June 27, 2001
BEI Job. No. 201064

**Subject: Phase II Subsurface Investigation Workplan
819-823 East 12th Street
Oakland, California**

SITE PLAN

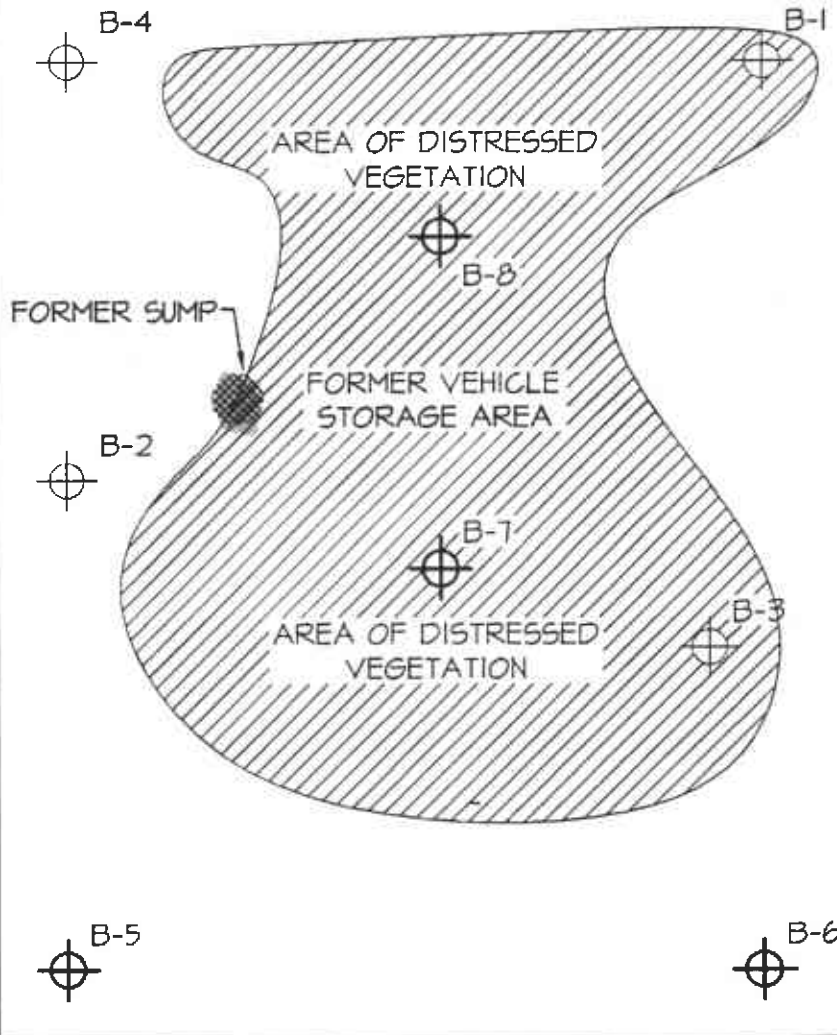
one SB should be a downed
by "former" sump near
